# MINUTES

## COUNCIL MEETING

### 2.1. Amendment C339ggee Flood Zones and Overlays - Review of Complex Submissions - Lara, Avalon and Fyansford

Amendment C339ggee Flood zones and overlays – Review of Complex Submissions - Summary and Response Table July 2022

**AMENDMENT C339ggee REVIEW OF  
COMPLEX SUBMISSIONS JULY 2022**  
Map 3 - The Centreway Lara

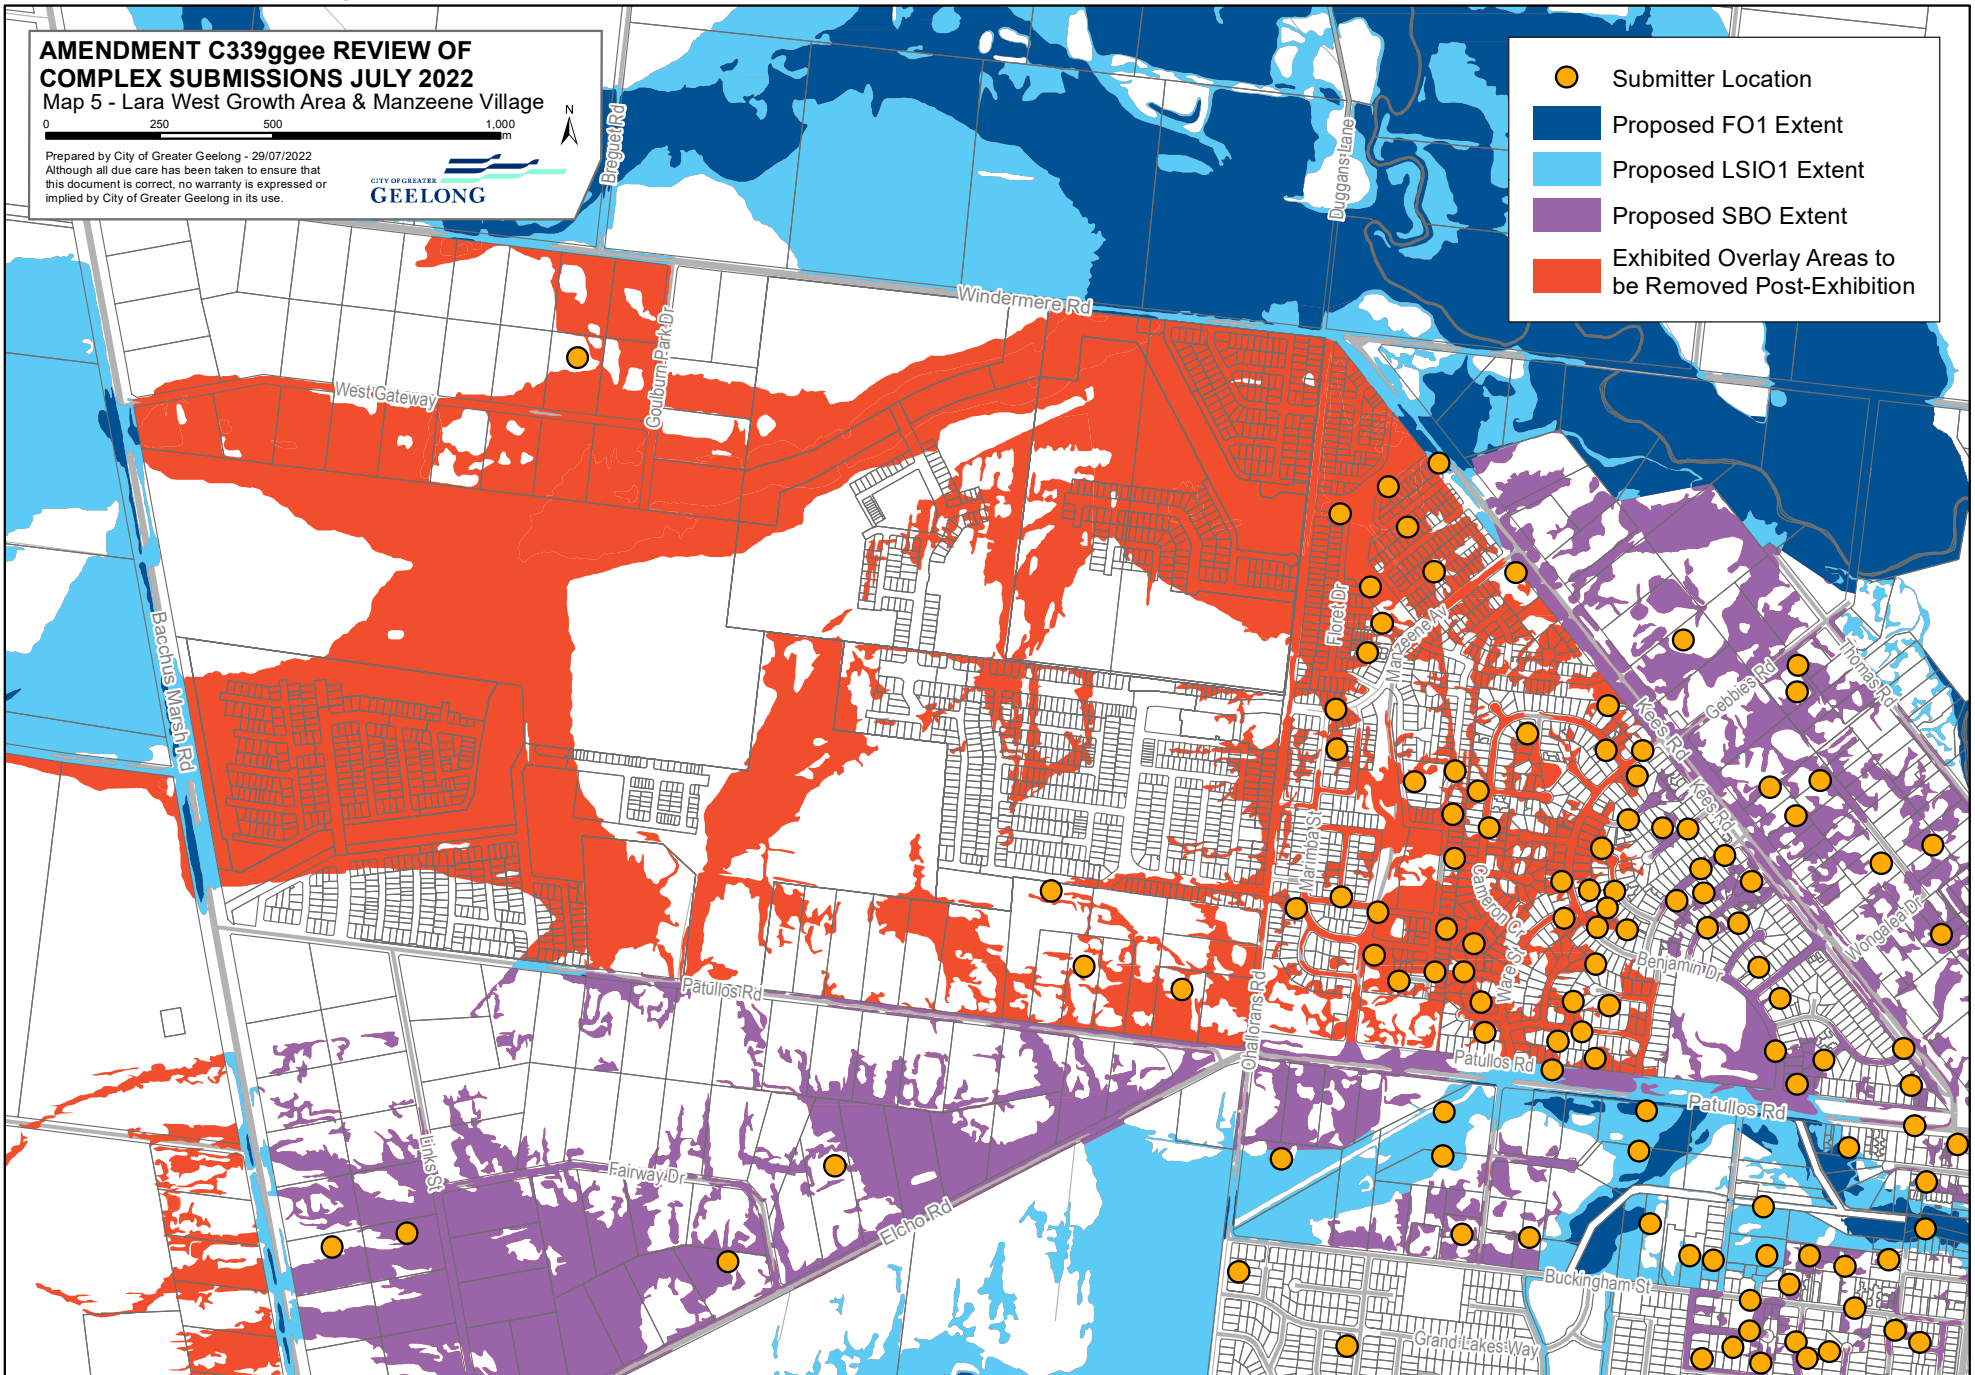
410	ROAD Securities	Grosvenor Drive	Wandana Heights	CoGG Engineering	SBO	<p>The current floor slab is about 250mm above the existing gutter. Also cites other examples where modelling contradicts real world.</p>	<p>This submission requests amendment of the Special Building Overlay due to minor encroachment of their property. Less than 1m2 of the property is proposed to be encumbered. Modelling outputs show the depth of water in the affected corner is 0.03m (30mm).</p> 	<p>Yes - clip overlay to exclude property</p> <p>See Map 3</p>

Figure 1 Submission Location

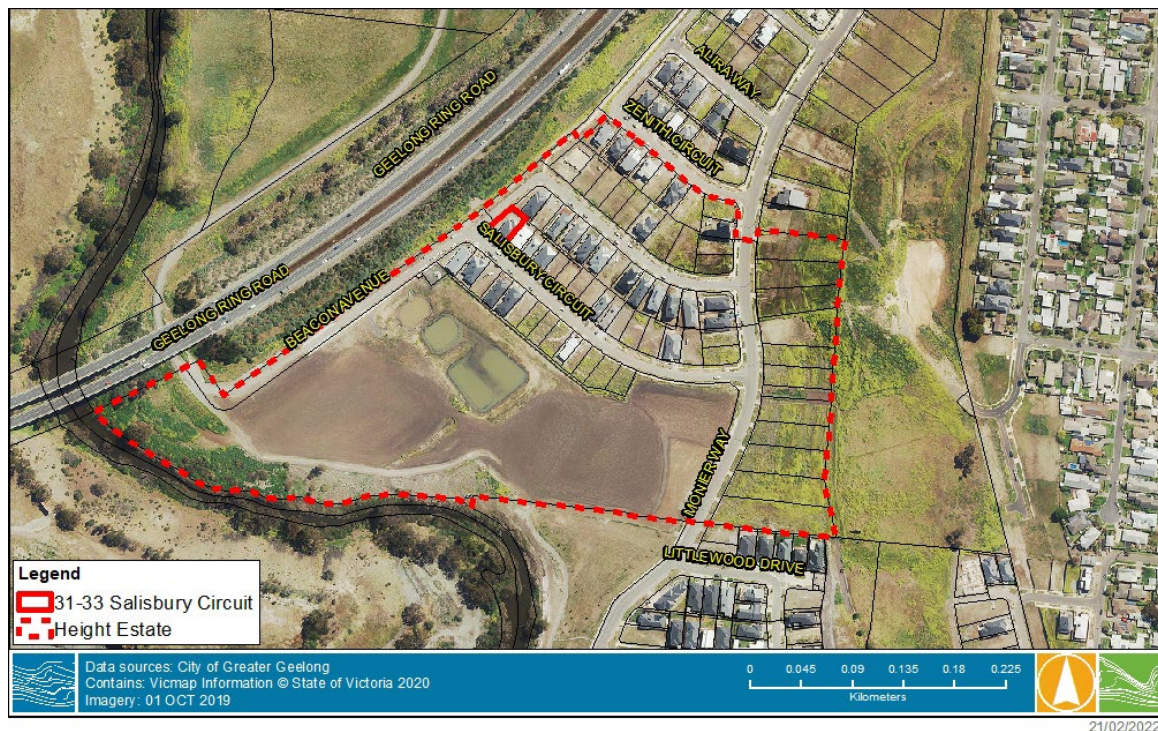
The location of the submissions received is shown below in Figure 1 for the following:

- The Heights (estate)
- 31-33 Salisbury Circuit, Fyansford

Figure 3 Existing and Exhibited Planning Layers

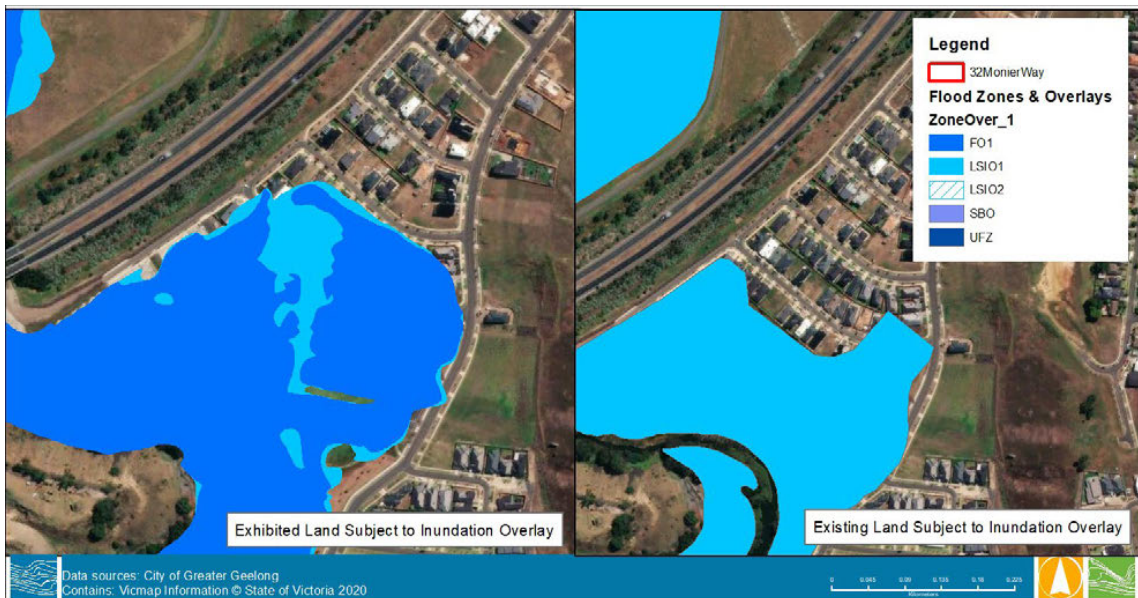
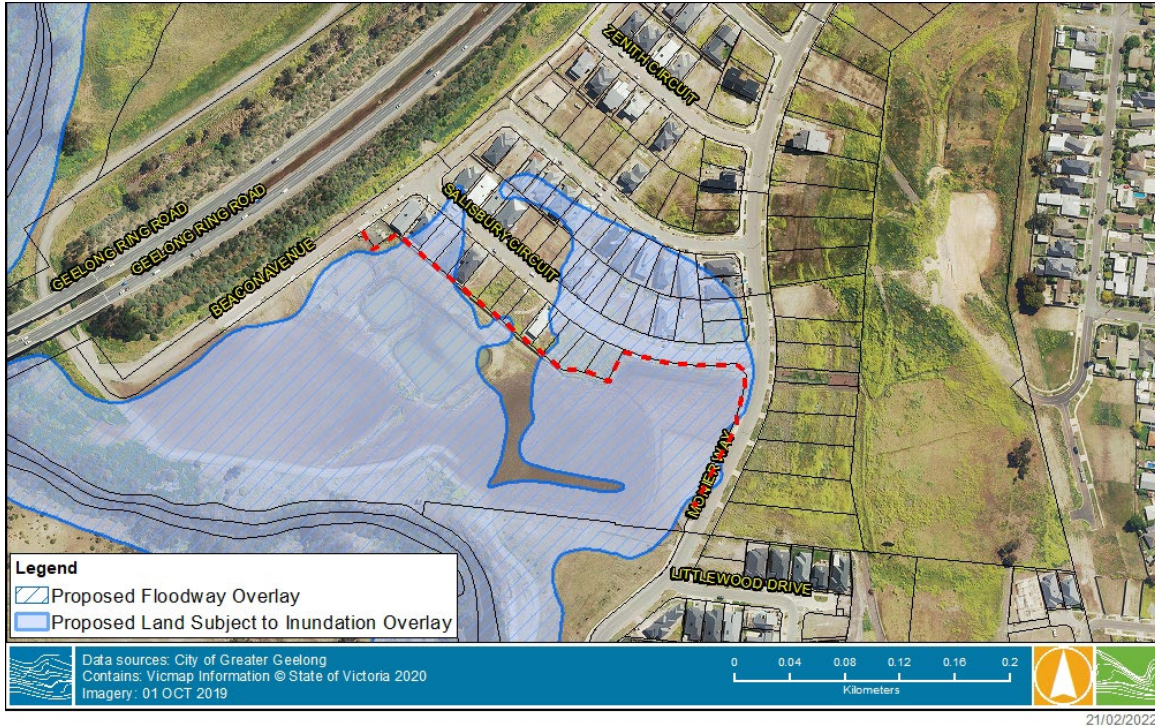
Figure 2 below, which compares the topography from the Lower Barwon and Lower Moorabool River Flood Study with more current survey levels. Figure 3 show the existing and exhibited LSIO layers side by side. This highlights that the exhibited layer is not reflective of the current topography as discussed above.

It is therefore recommended that the exhibited LSIO map be clipped to the extent of filling within the Heights development. The Figure 4 below shows the exhibited clipped flooding extent at the location (dashed red line).

Figure 6 Topography Comparison

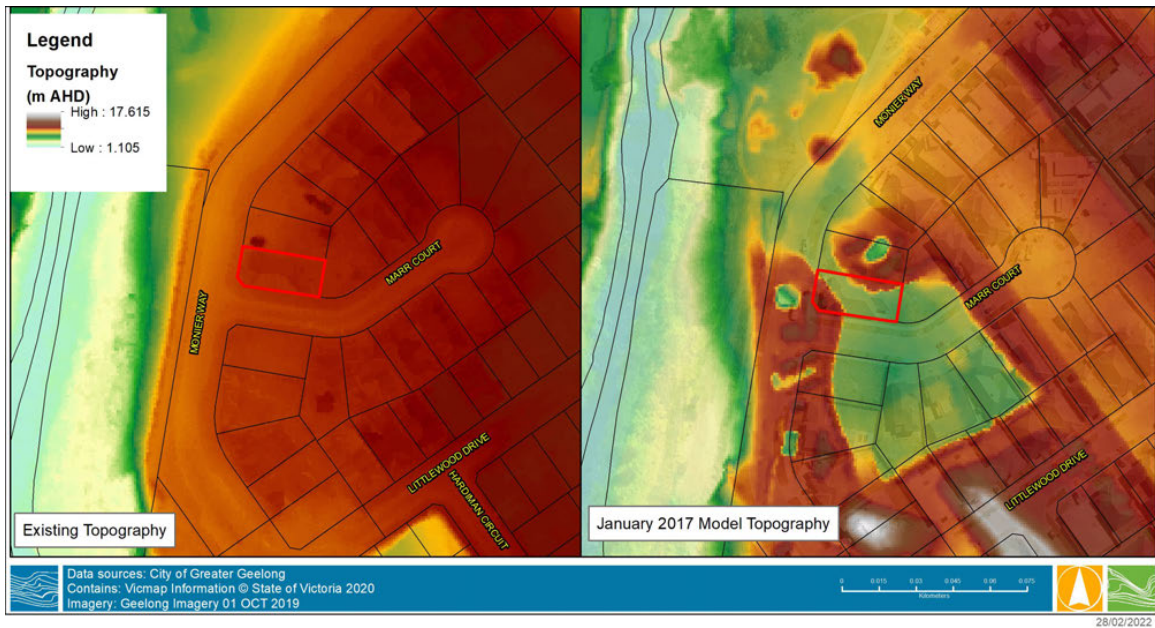
It is understood that ground levels within the lowest sections of the estate have now been raised. Approved plans provided to council indicate that ground levels within Monier Way and the sections shown to be flooded in the exhibited C339 overlay have been raised to 9.3 – 9.6 metres AHD along Monier Way. Figure 6 shows a side-by-side comparison of the existing and flood-study topography, highlighted where the lots have been filled. Figure 7 shows a comparison of the existing and exhibited LSIO layers.

It is therefore recommended that the exhibited LSIO map be clipped to the extent of filling within this area of development. The Figure 8 below shows the exhibited clipped flooding extent at the location (dashed red line).

Figure 10 Topography Comparison

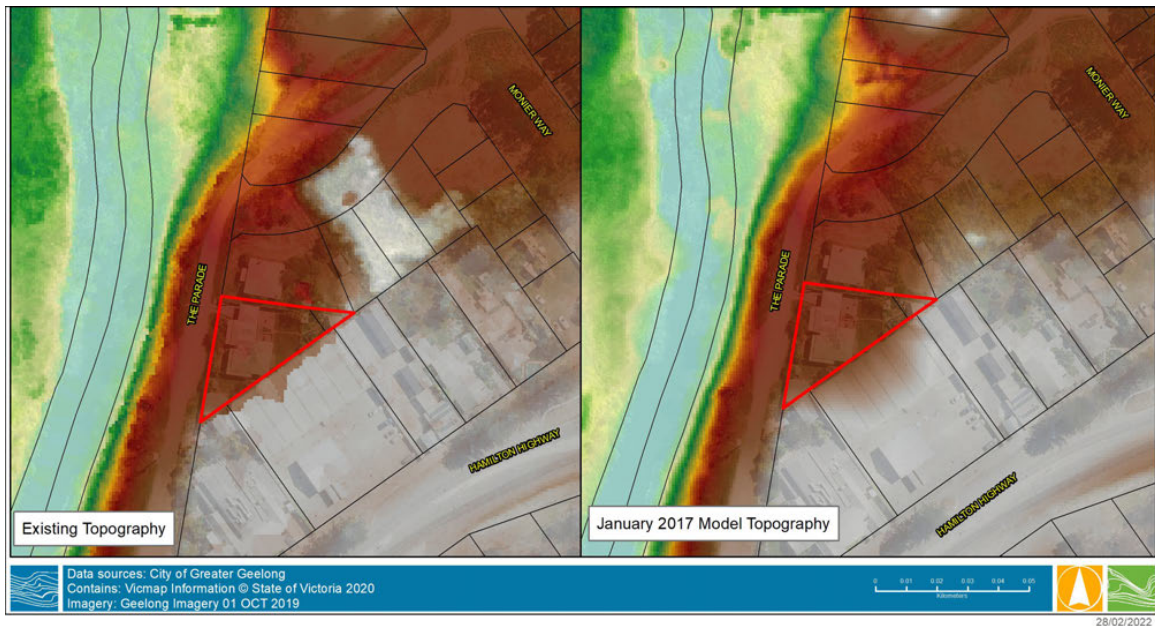
The topographic information on which the Lower Barwon and Lower Moorabool Flood Study was based on aerial survey collected in January 2017. Ground levels on the subject property are understood to range between 7.1 – 7.6 metres AHD. The 1% AEP design flood levels and corresponding flood extent on which the Land Subject to Inundation Overlay is based, are around 8.15 m AHD in this area. The topographic data is shown in Figure 10. Figure 11 shows a comparison between current and exhibited flood overlays.

Whilst it is acknowledged that the existing flood modelling within this section of the floodplain does not account for filling of the Gen Fyansford estate, the impact of filling is likely to be localised and only provide flood immunity to the areas shown to be filled above the applicable flood level. Having regard to this it is recommended that the LSIO and FO extent in this location be clipped to match the filled area as shown in Figure 12.

Figure 14 Submission Sites

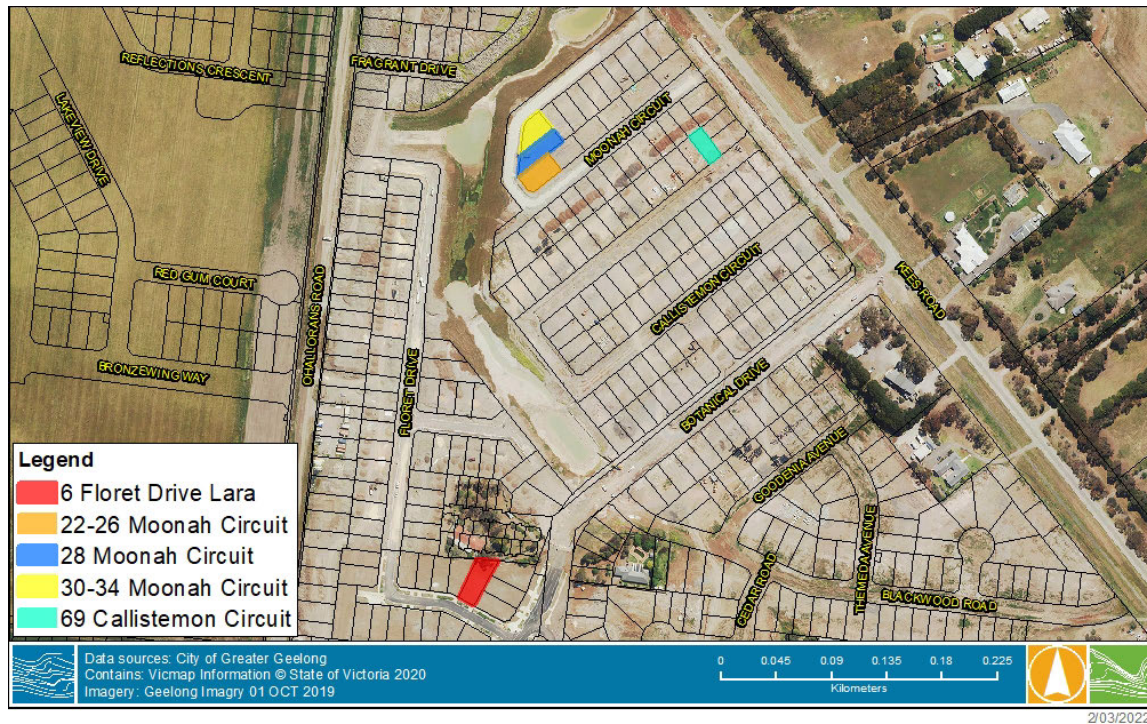
The locations of the submissions received are shown below in Figure 14 for the following:

Figure 15 Submission Site

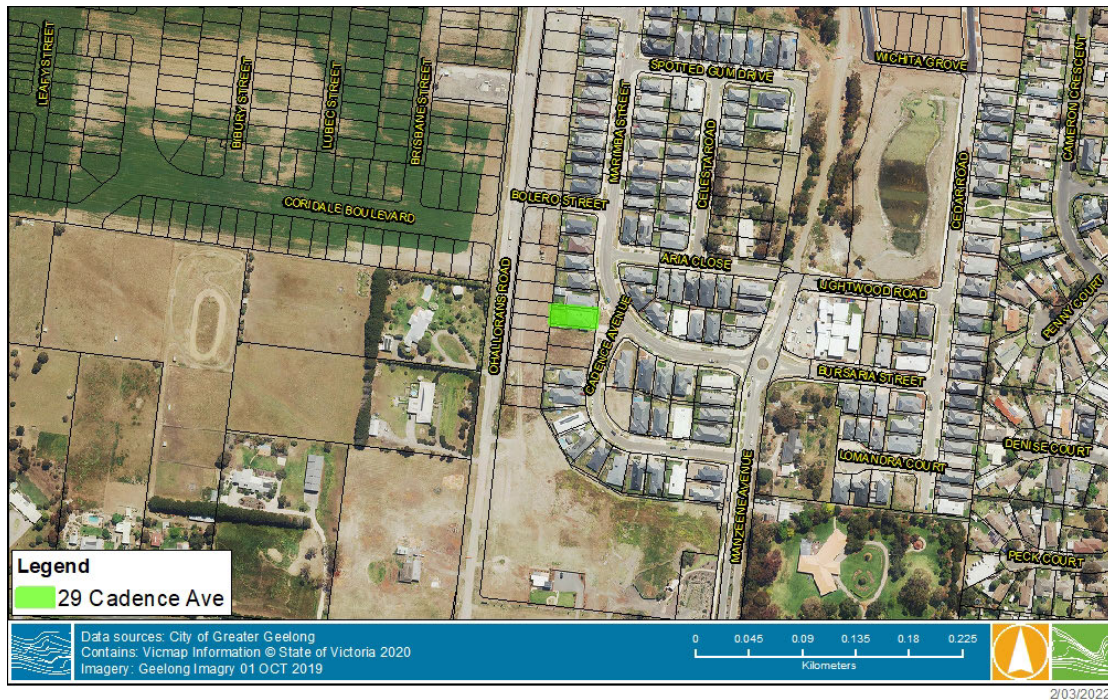
The location of the submission received for the address below is shown in Figure 15.

- 29 Cadence Ave, Lara

Figure 16 Comparison of flooding at Lara

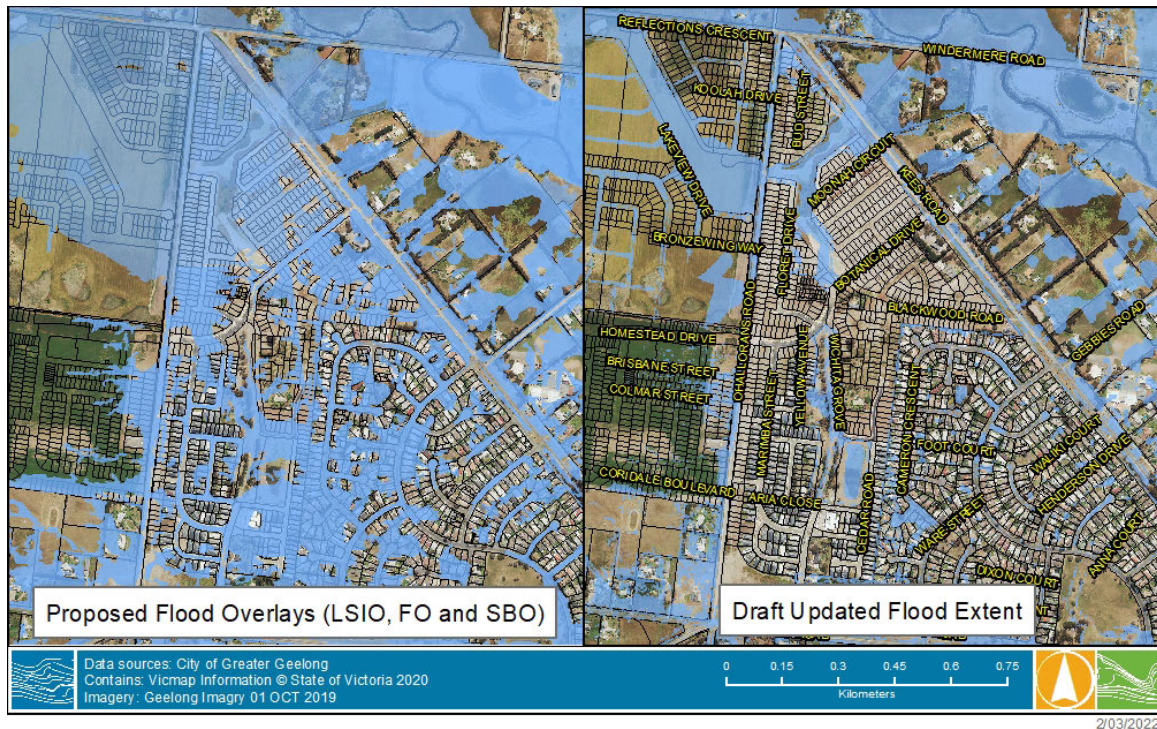
A comparison of the exhibited SBO extent and the draft updated flood extent is shown in Figure 16 below.

Figure 18 Submission Sites

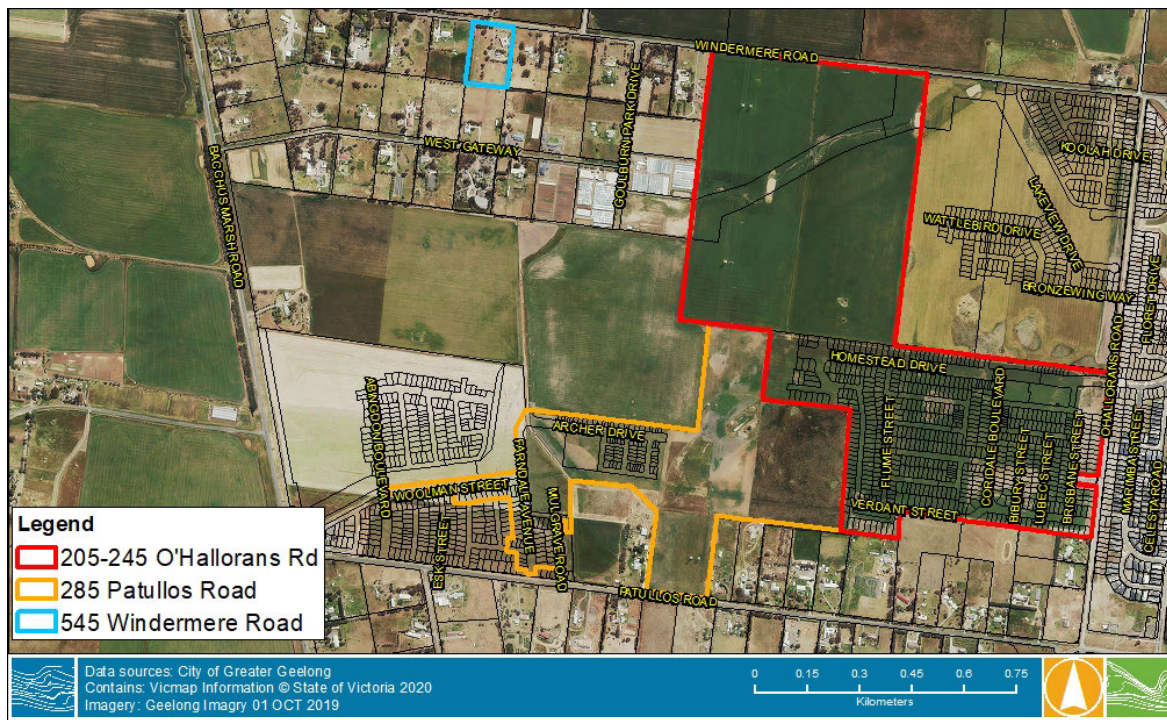
The locations of the submissions received are shown below in Figure 17:

- 205-545 O'Hallorans Road, Lara
- 285 Patullos Road, Lara
- 545 Windermere Road, Lara

Whilst the property at 545 Windermere Road shown in Figure 18 is recommended to be removed for this amendment it is also recommended that the flood prone designation remain in place. Unlike the other two properties identified in this area, 545 Windermere Road is not part of the larger land holdings where works are ongoing to develop the Lara West area. Hence there is no immediate plan to resolve flooding risk here, with no current application to develop the site. This means there is residual flood risk across the site until such time as development within this area of Lara West proceeds and residual flood risks are addressed.
